**BEAMREACH NETWORKS, INC.
BELL SOUTH CORPORATION
VERIZON WIRELESS, INC.
WORLD COM, INC.**

*Re: Establishment of Rules and Policies for the Satellite
Digital Audio Radio Service in the 2310-2360 MHz Band;
IB Docket No. 95-91*

Response to XM Radio's Supplement to August 29, 2001 White Paper¹

Figure 22
SDARS (XM & Sirius) Vs. WorldCom (FWO03)

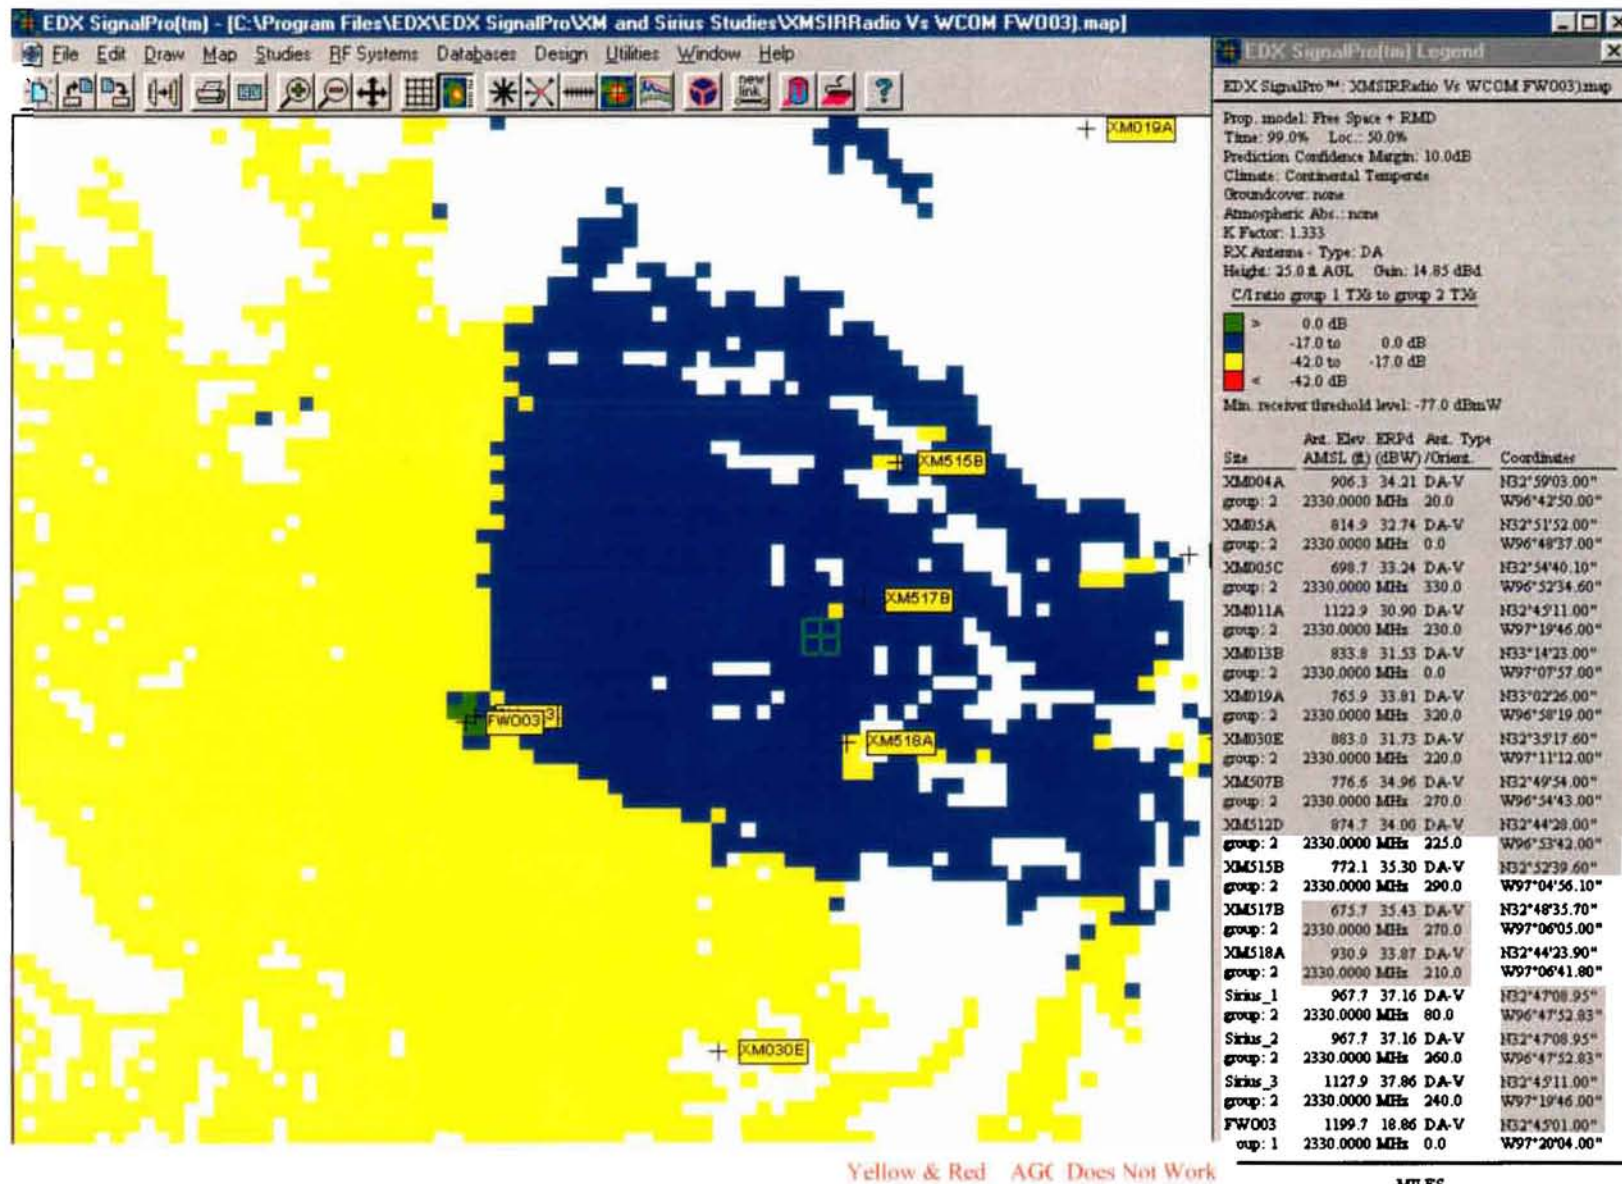
In Figure 22 the simulation looks at the RF coverage area of WCS base station DAL08. The WCS CPE in the WCS cell coverage area is equipped with RF front-end AGC.

- The colors green and blue represent areas where the receive levels have a power gap of 17 dB or less. These areas are where the WCS system with AGC could mitigate any harmful interference. The SDARS base station does not cover most of the green and blue areas.
- The areas colored by yellow are the areas where AGC does not work for intermodulation interference.
- The areas colored in red are where the AGC does not work for overload interference. There is very little red area in this figure.
